**CHANGE TO THE OPERABLE UNIT 3 BUILDING 4A IMPLEMENTATION  
PLAN FOR THE ABOVE GRADE DECONTAMINATION AND DISMANTLEMENT**

DOE-1245-95

**CHANGE TO THE OPERABLE UNIT 3 BUILDING 4A IMPLEMENTATION PLAN FOR ABOVE-GRADE DECONTAMINATION AND DISMANTLEMENT**

FIGURE 2-1 Proposed Locations For Plant 4 Complex Air Monitors

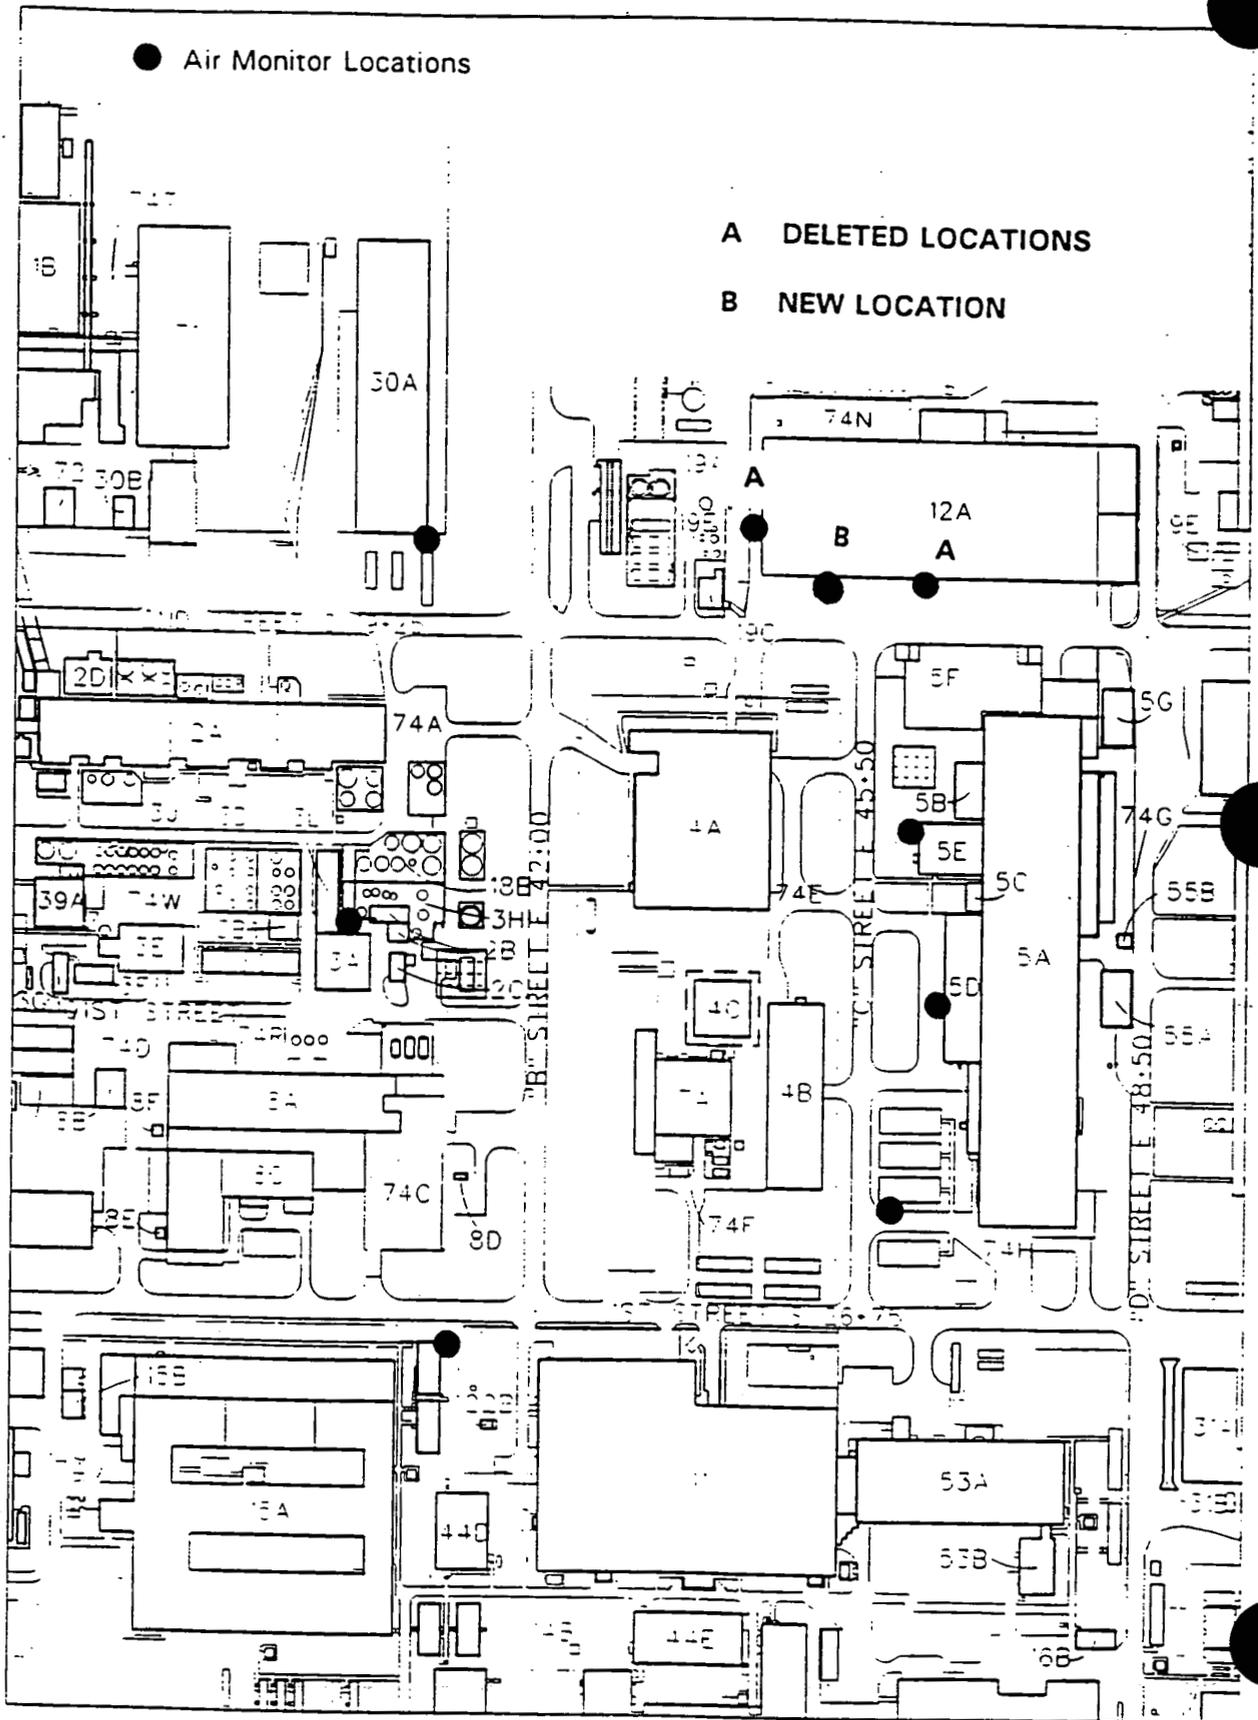
The intent of this letter is to request your concurrence to a change to the Operable Unit 3 (OU3) Building 4A Implementation Plan for Above-Grade Decontamination and Dismantlement for supplemental radiological air monitoring. Air quality monitoring that is being performed during the Building 4A decontamination and dismantlement project includes two programs: 1) The current site-wide monitoring program plan, and 2) the Supplemental Radiological Air Monitoring Program, specifically designed for the decontamination and dismantlement of Building 4A as discussed in Section 3.7.3 of the OU3 Remedial Design/Remedial Action (RD/RA) Work Plan. The OU3 Building 4A Implementation Plan for Above-Grade Decontamination and Dismantlement (Final, March 1995) further defines the Supplemental Radiological Air Monitoring Program. Section 2.3 of the OU3 Building Implementation Plan states:

"Based on the factors listed in Section 3.7.3 of the OU3 RD/RA Work Plan, air emissions modeling was performed to determine the potential emissions from remediation. The results of that modeling effort indicate levels of radiological emission will not exceed the 0.1 mrem/year threshold at the project boundary that would require continuous emissions monitoring. However, as a conservative measure to ensure protection of human health and the environment, eight continuous air monitors will be employed to supplement current site-wide air monitoring on a continual basis surrounding the project boundaries during the interim remedial action. These monitoring locations for Building 4A are identified in Figure 2-1."

Prior to placing the monitors in the field, the location and the number of continuous air monitors required to meet the intent of the OU3 RD/RA Work Plan and Building 4A Implementation Plan (IP) were further reviewed. The review was based on the following factors: Expected dispersion of airborne releases, representativeness of the monitoring locations; the potential hazard of the material to be released; and accessibility to the monitoring station. Based on this review, it was determined that seven continuous monitors were adequate to meet the requirements of the OU3 RD/RA Work Plan and Building 4A IP. The Building 4A enclosed Figure 2-1 indicates a monitor should be placed on both the west wall and the south wall of Building 12A. These locations have been combined and a single monitor has been employed along the south wall of Building 12A, west of the original location located along the south wall. The original locations are in close proximity to one another and it appears would add no additional value to the air monitoring program. The new location will provide data that is representative of the two previously proposed locations. The new location increases the accessibility to the air monitoring station for maintenance and calibration without sacrificing the ability to detect the anticipated dispersion of airborne releases. Combining these two monitoring locations will not decrease the ability of the monitoring program to meet the OU3 RD/RA Work Plan objectives. Also, enclosed are the summary analytical results for the seven monitoring locations for April, May, and June.

As stated in Section 4.6.5, Remedial Action Reports, of the OU3 RD/RA Work Plan, any modifications to the OU3 RD/RA Work Plan and/or IP is required to be documented in the Remedial Action Report. This change to the Supplemental Radiological Air Monitoring Program will be documented in the Building 4A Remedial Action Report.
